To: T10 Technical Committee
 From: Rob Elliott, HP (elliott@hp.com)
 Date: 25 October 2003
 Subject: 03-186r3r3 SAS-1.1 Transport layer retries

Overview

Figure 2 — ST_I (transport layer for SSP initiator ports) state machines

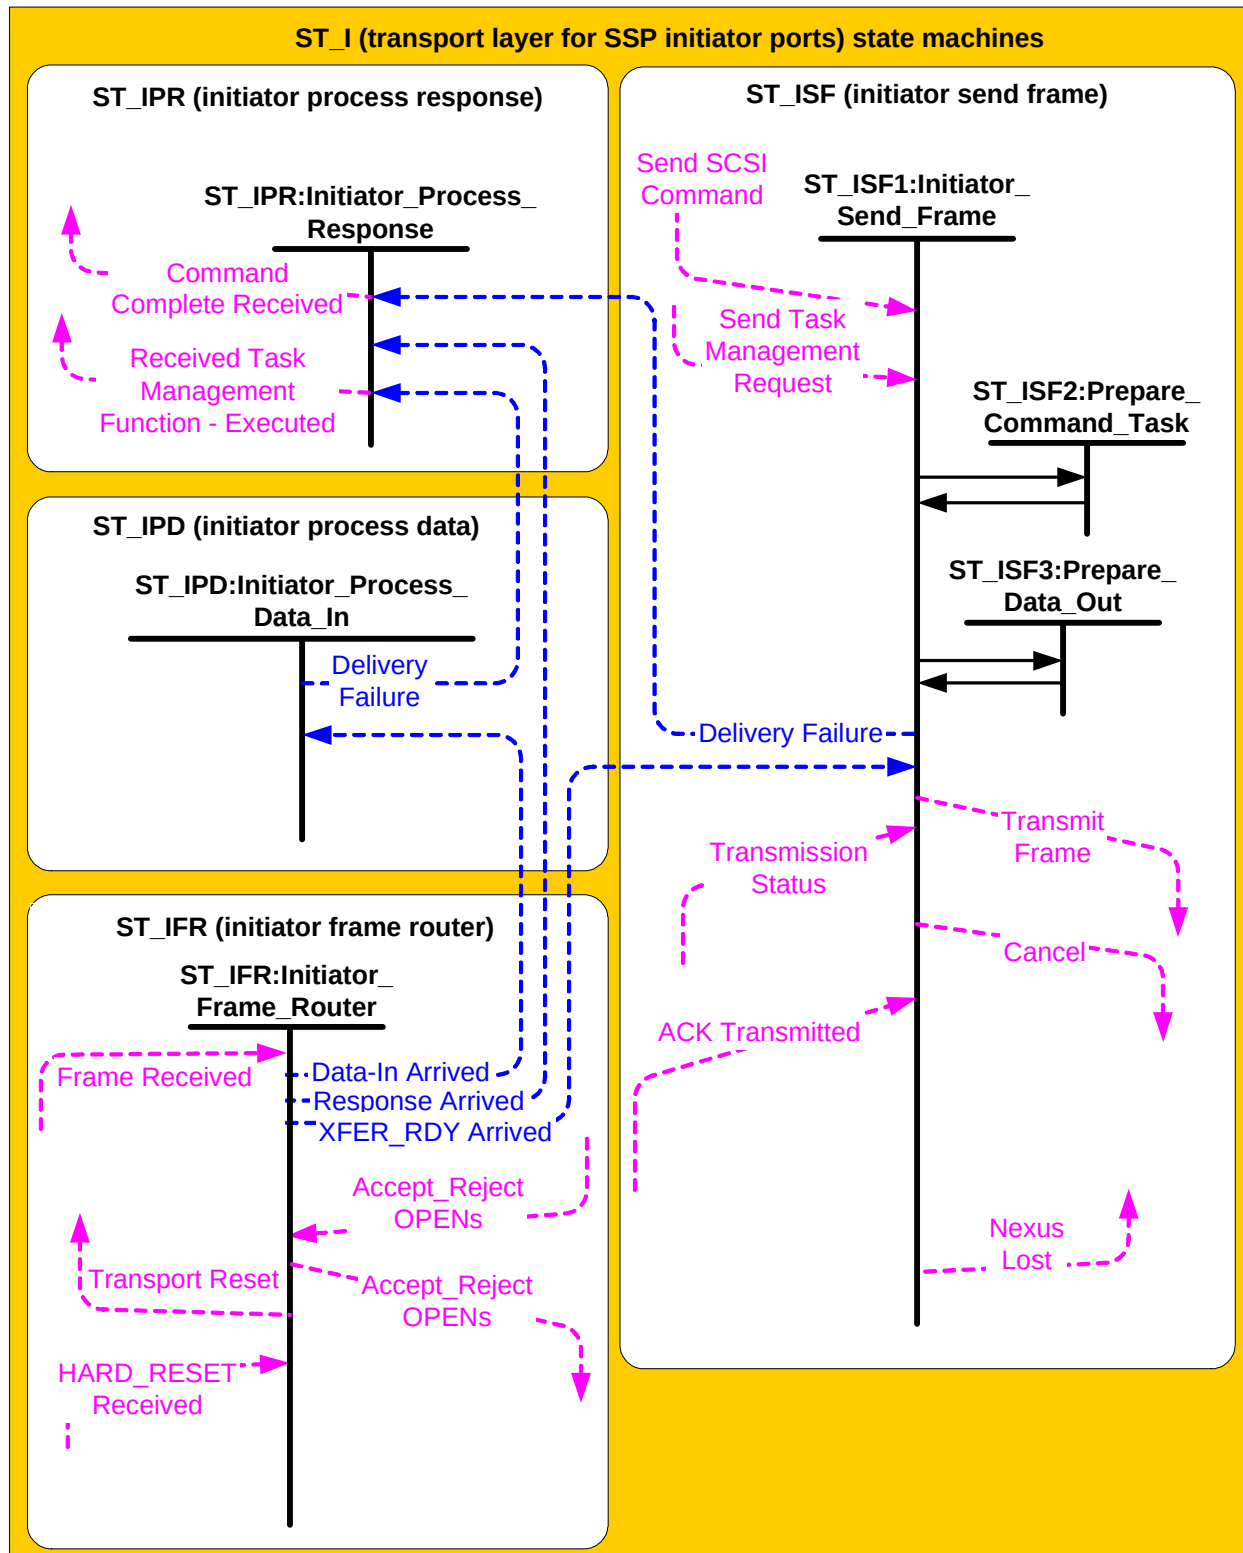
9.2.6 ST (transport layer for SSP ports) state machines [\[modifications throughout\]](#)

Figure 2 shows the ST_I state machines.

Figure 3 — ST_T (transport layer for SSP target ports) state machines

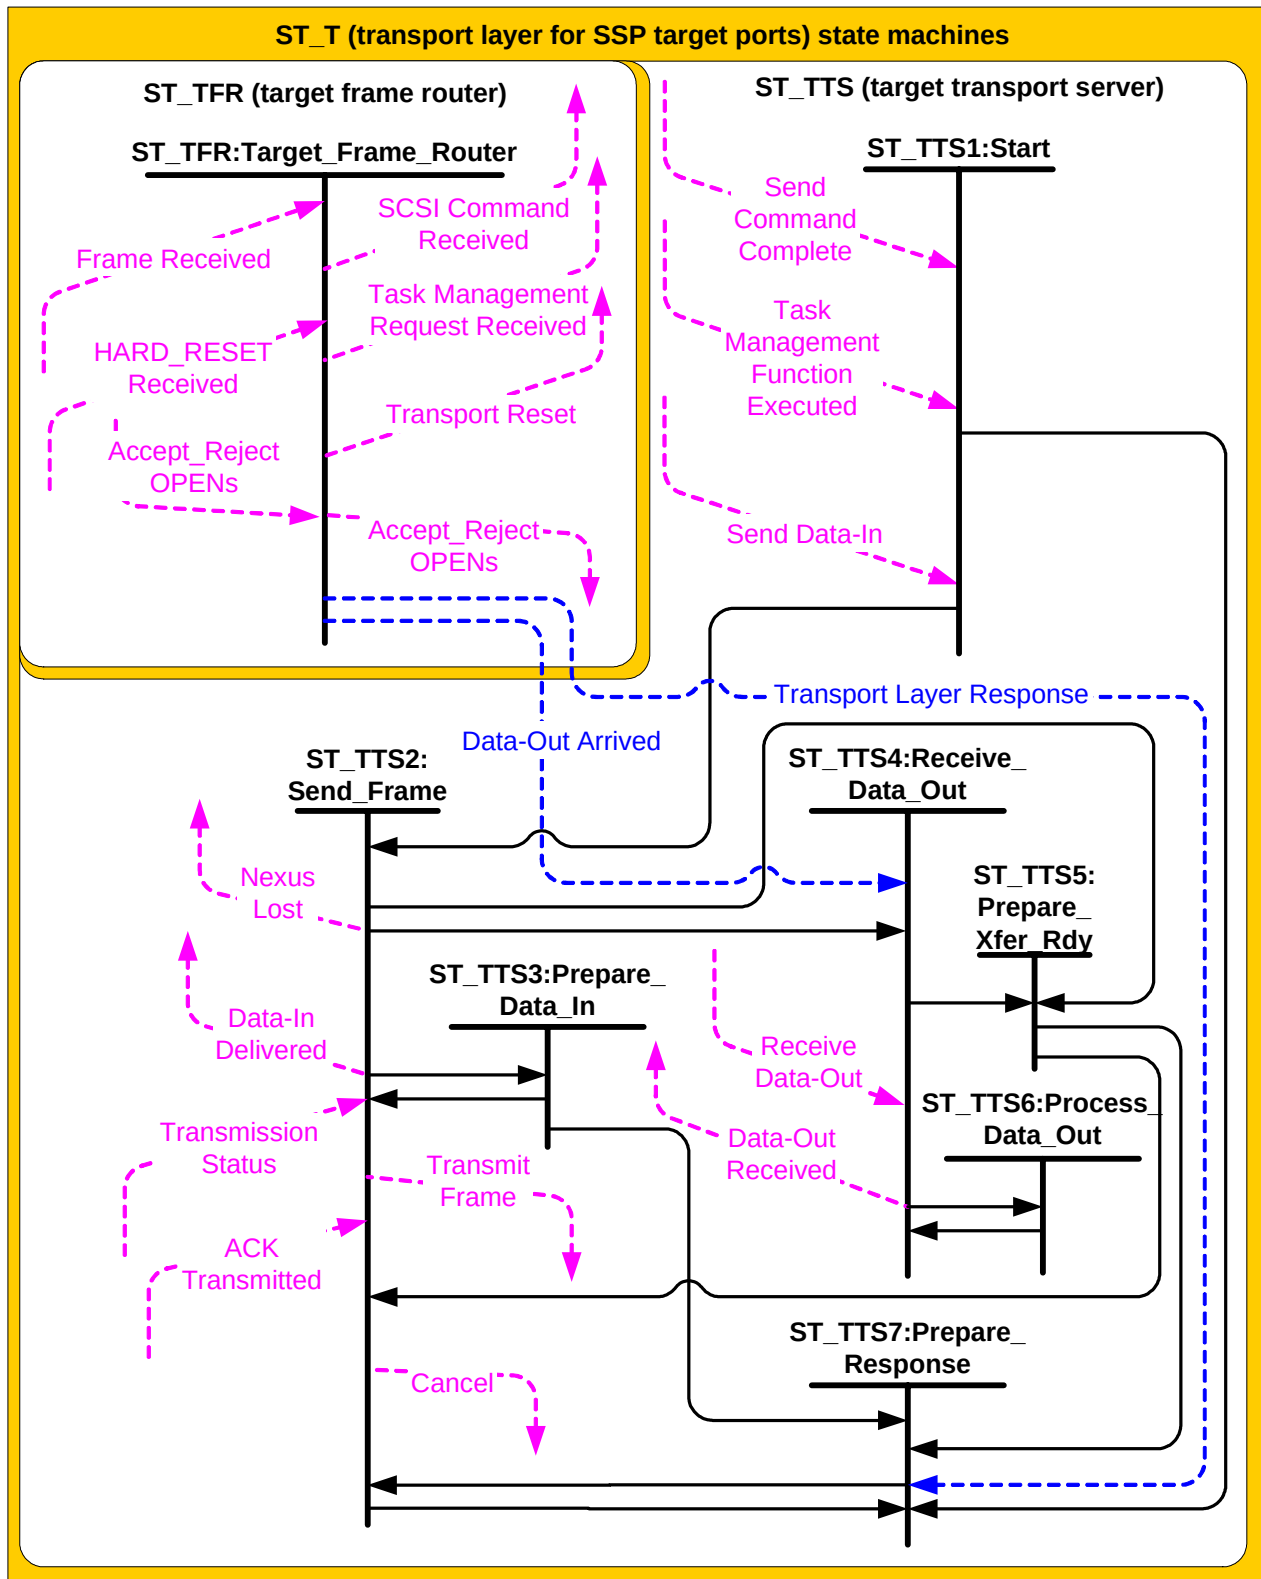
Figure 3 shows the ST_T state machines.
